ADDENDUM

PROJECT:	DPW #19230 Remodel Dietetics Foods Lab, Albion Hall, Idaho State University	ARCHITECT'S PROJECT NO:	1806
OWNER:	State of Idaho, Division of Public Works	ADDENDUM NUMBER:	1
BID DATE:	05.23.19	TIME:	10:30 p.m.
		ADDENDUM DATE:	05.17.19

DEMOLITION
PLAN

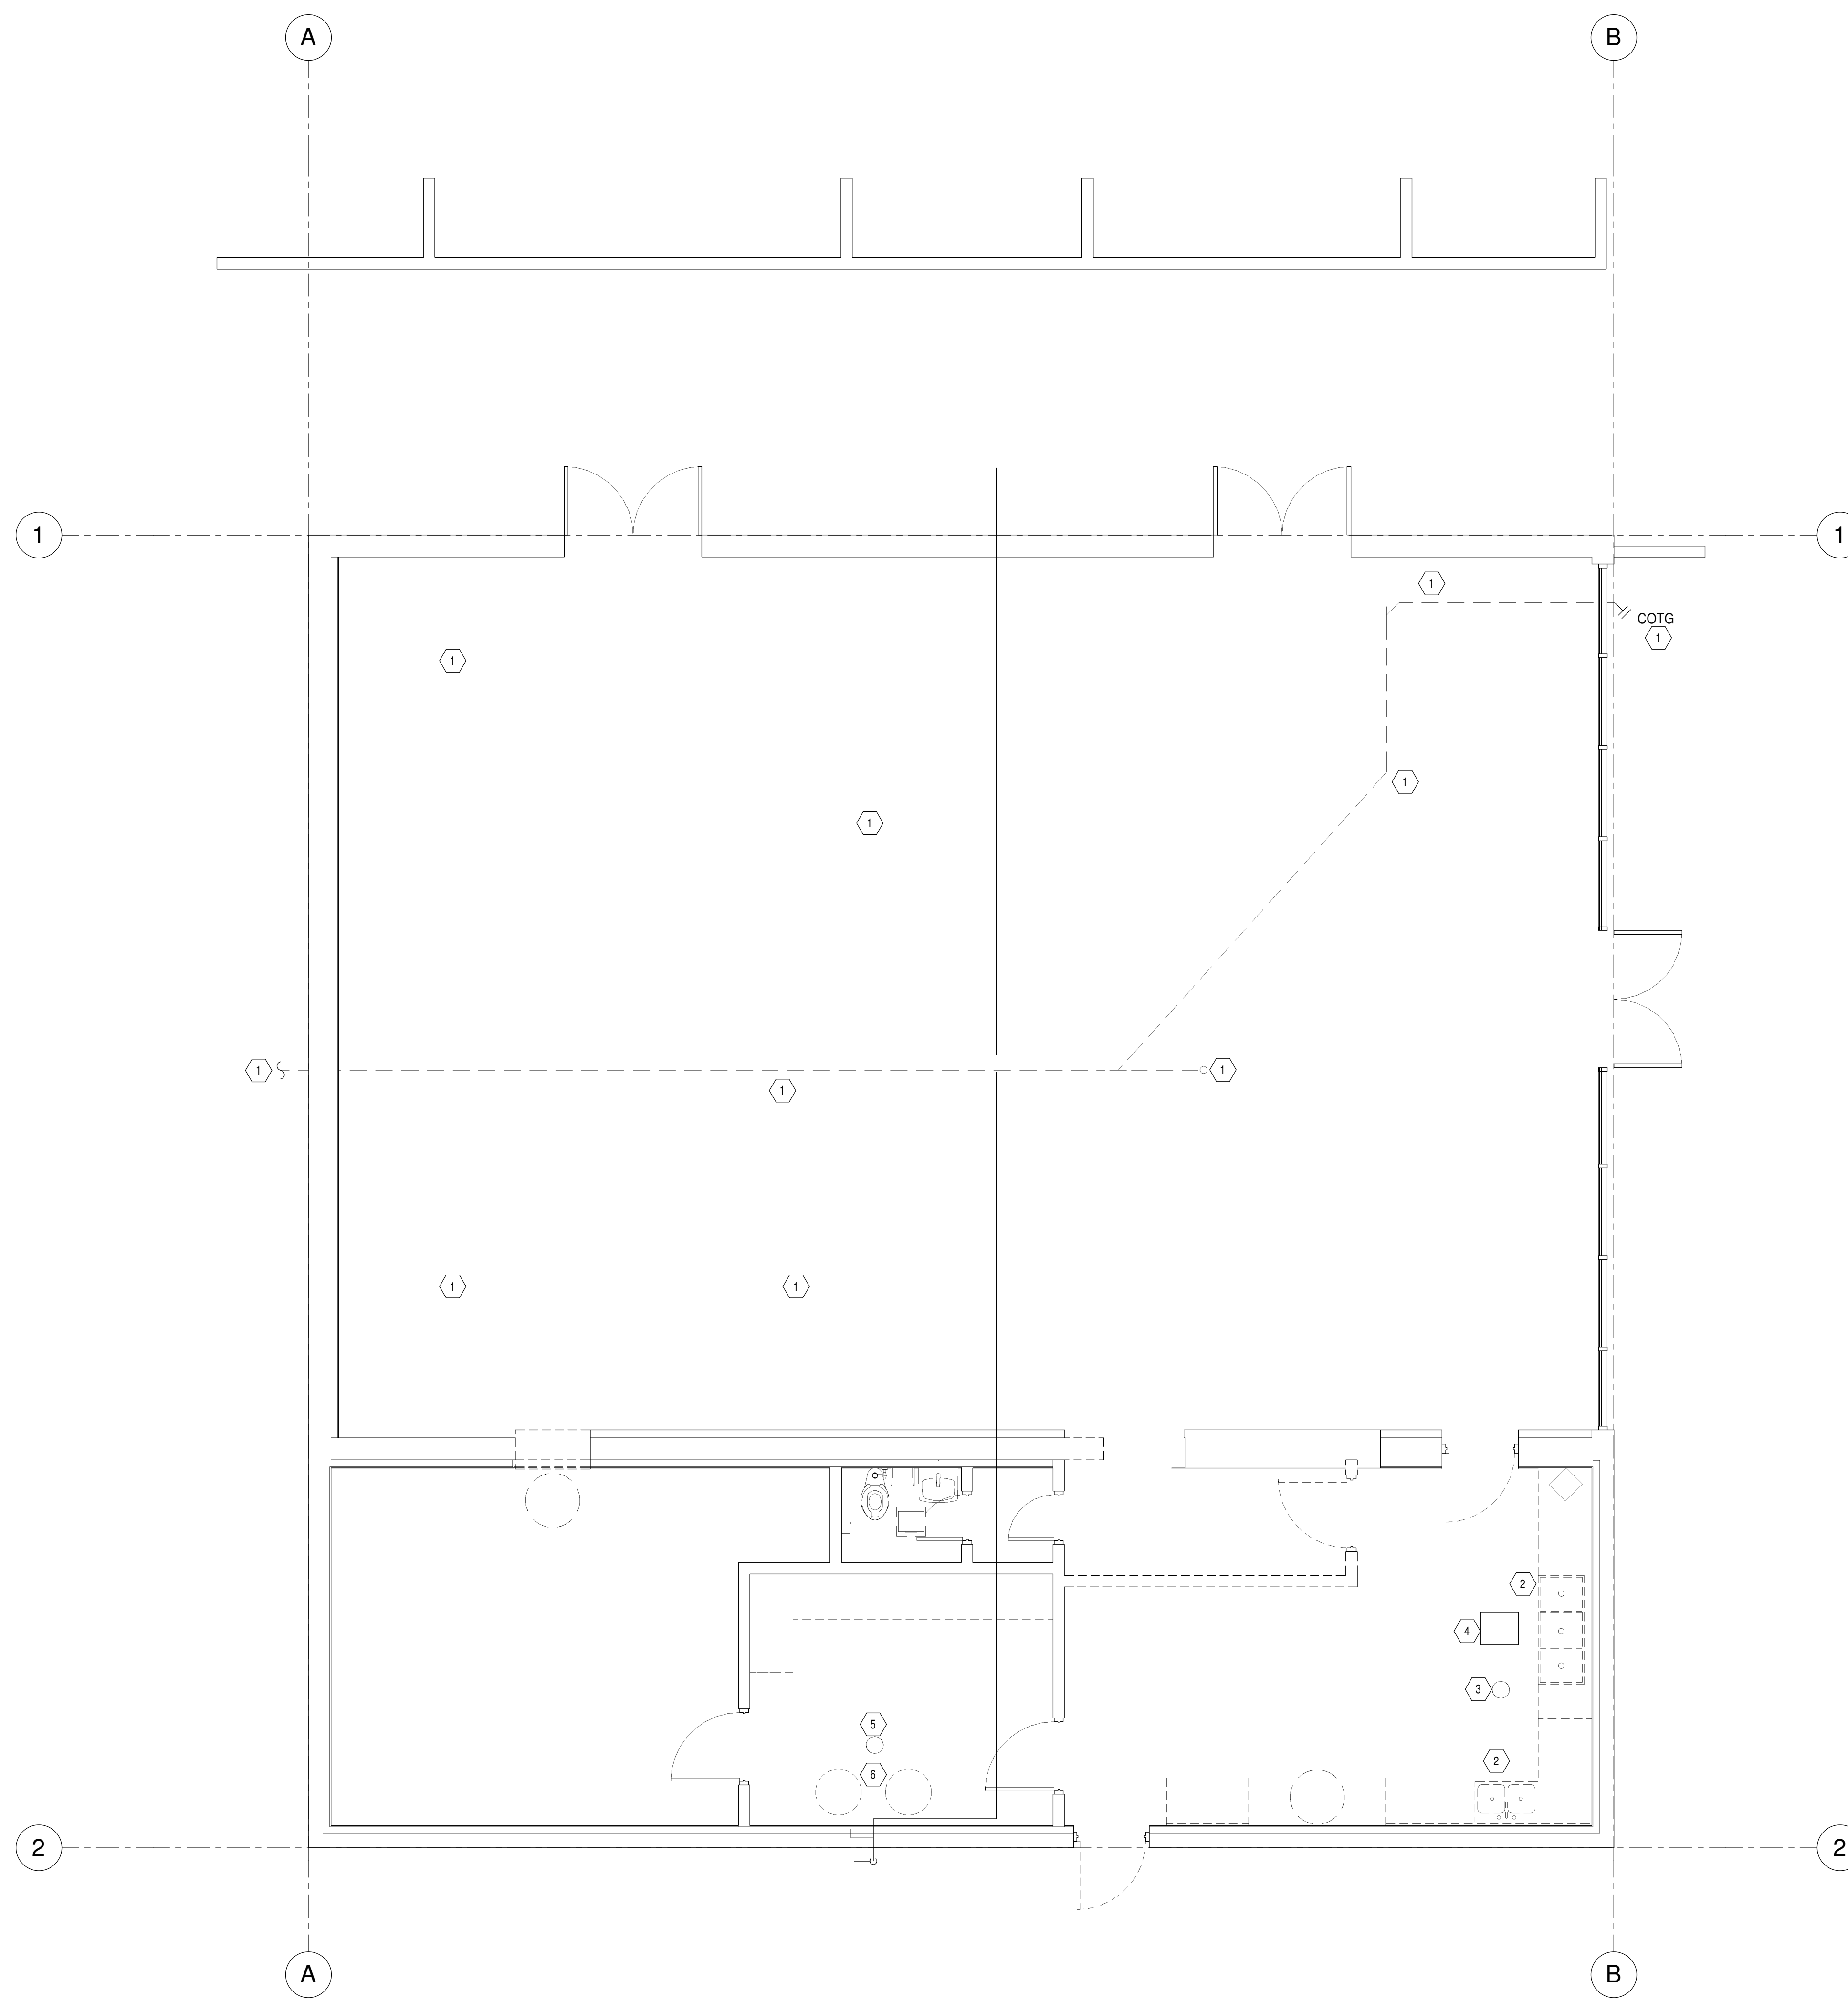
1. SHEET D1.1 – DEMOLITION PLAN
 - a. Revise Existing Kitchen – see attached Sheet D1.1 – Demolition Plan.

EXISTING ELECTRICAL PLAN

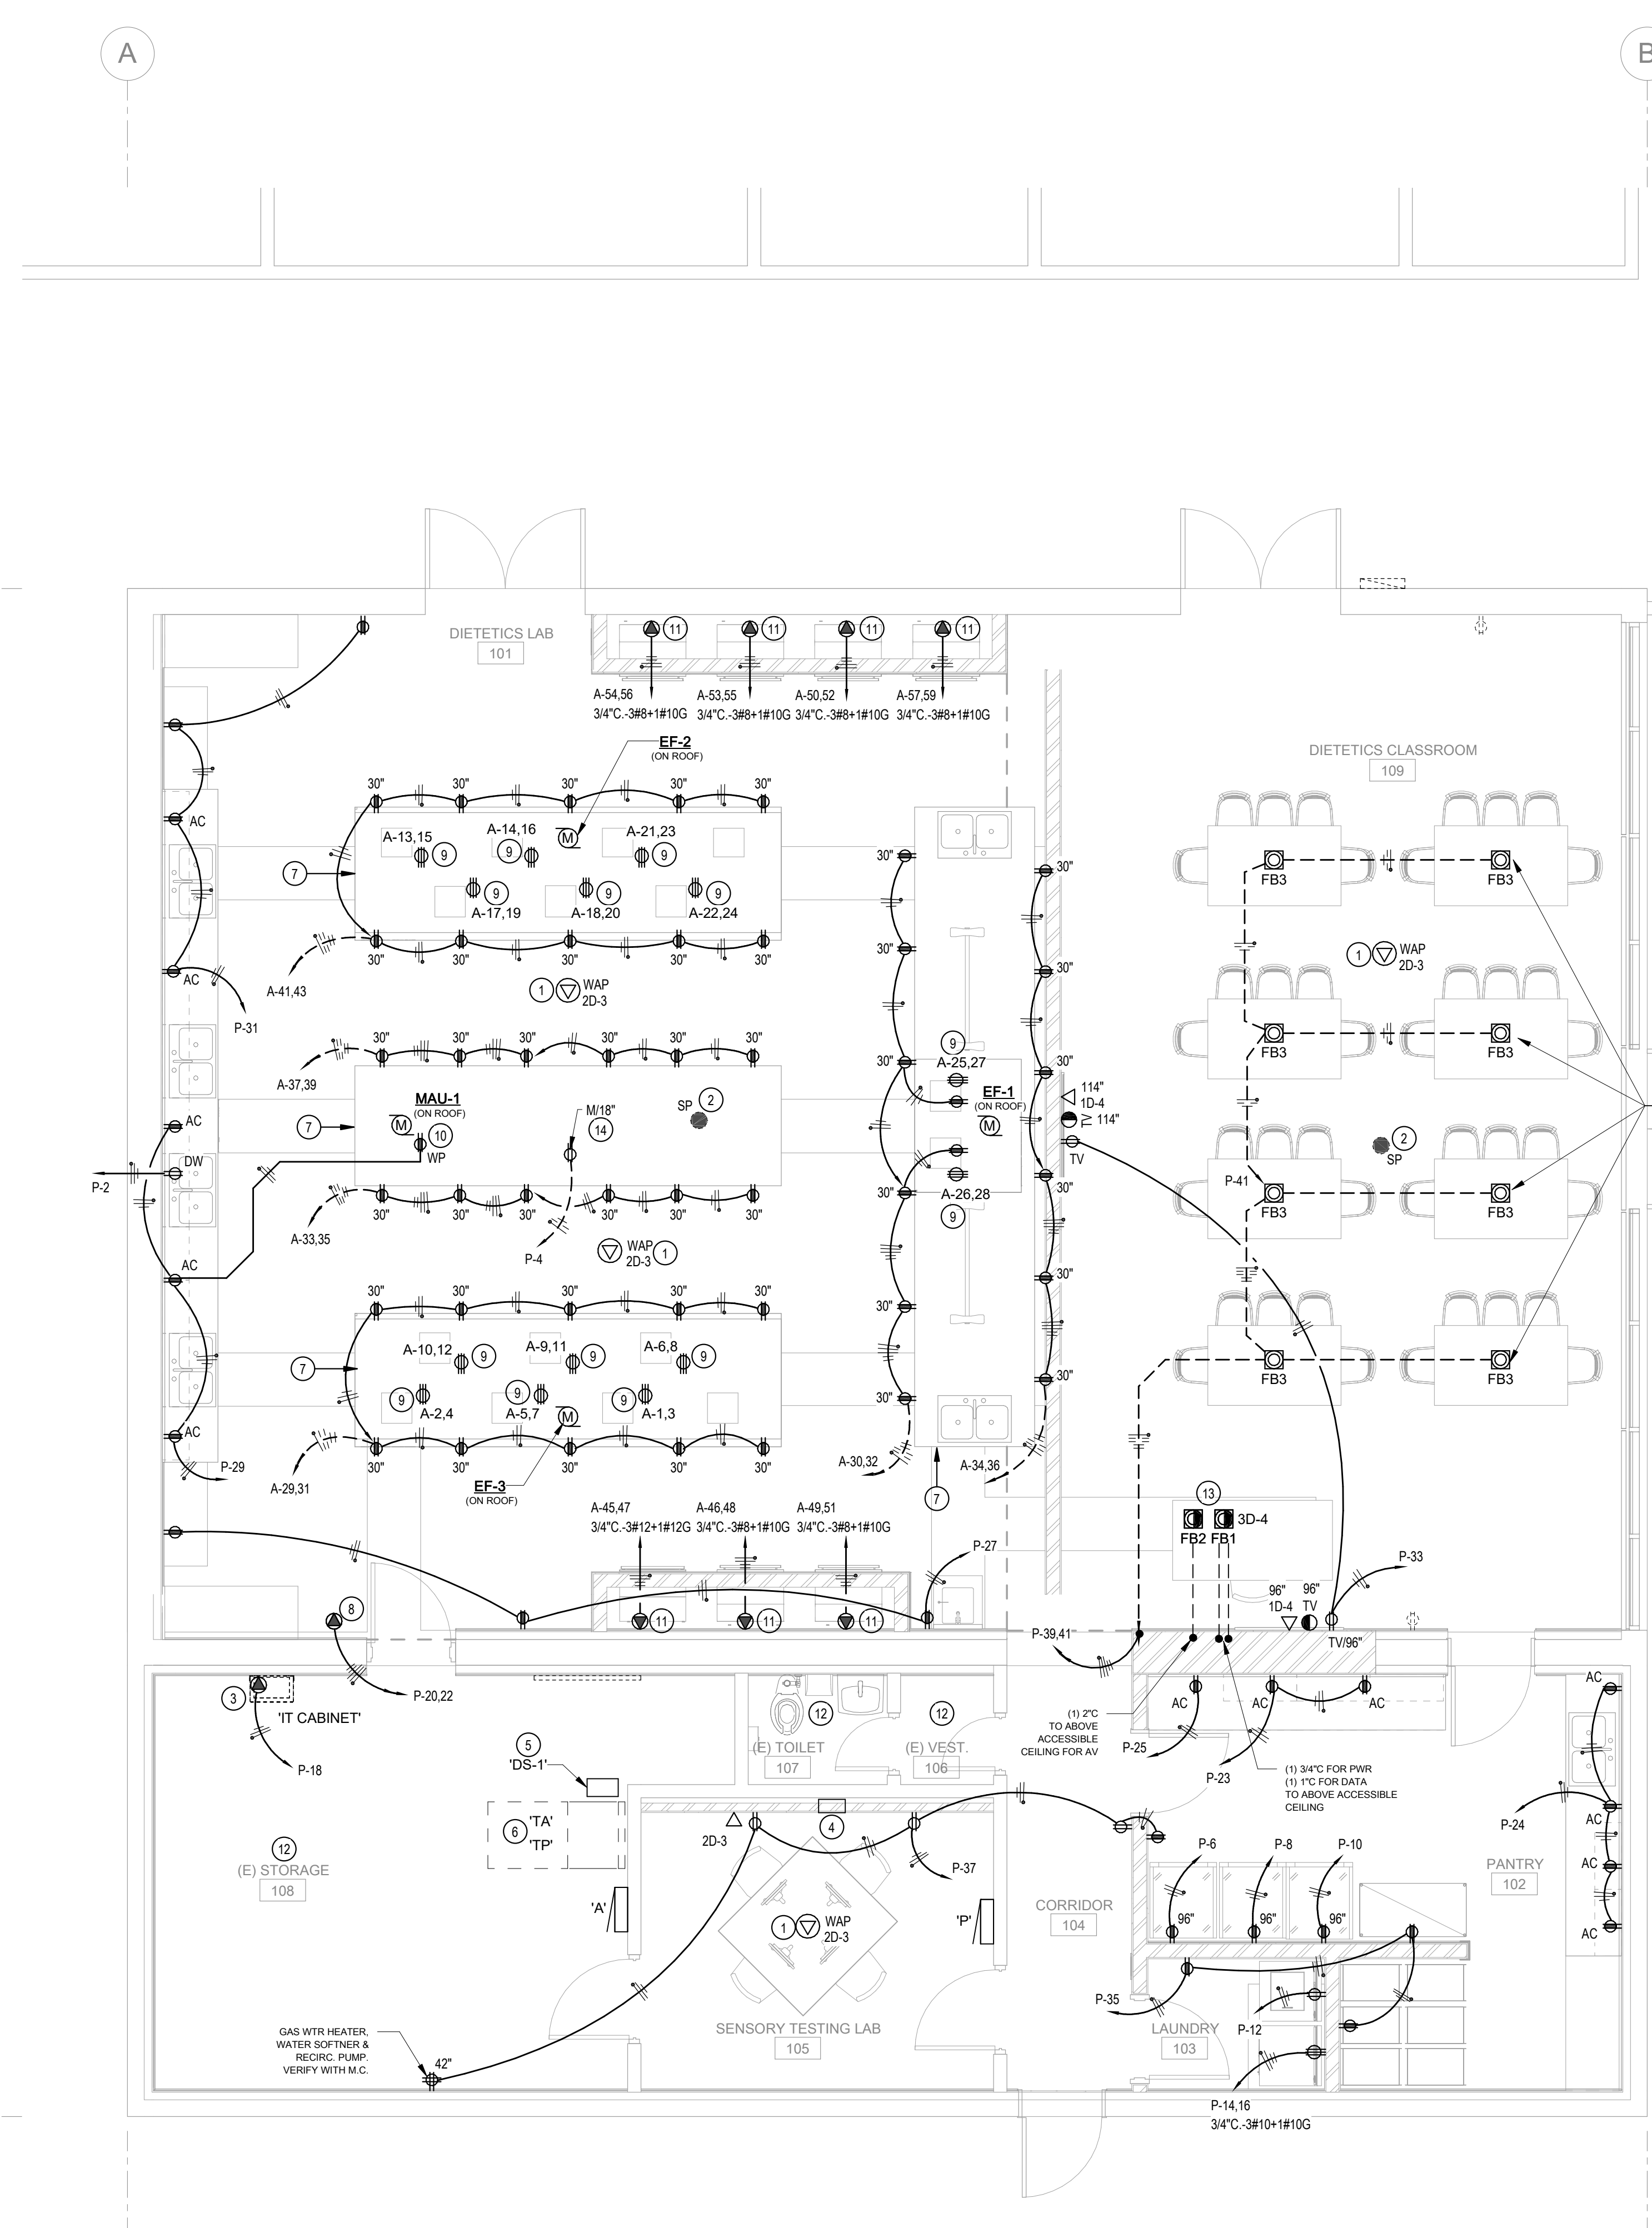
1. SHEET E0.1D – EXISTING ELECTRICAL PLAN
 - a. Existing Disconnect 'DS-1' shall be replaced with new fused disconnect – see attached Sheet E0.1D – Existing Electrical Plan.
2. SHEET E2.0 – POWER/DATA PLAN
 - a. Existing Disconnect 'DS-1' shall be replaced with new fused disconnect – see attached Sheet E2.0 – Power/Data Plan.
3. SHEET E5.0 – POWER RISER & SCHEDULES
 - a. Existing Disconnect 'DS-1' shall be replaced with new fused disconnect – see attached Sheet E5.0 – Power Riser & Schedules.
 - b. AIC calculations and ratings has been added to the panels – see attached Sheet E5.0 – Power Riser & Schedules.
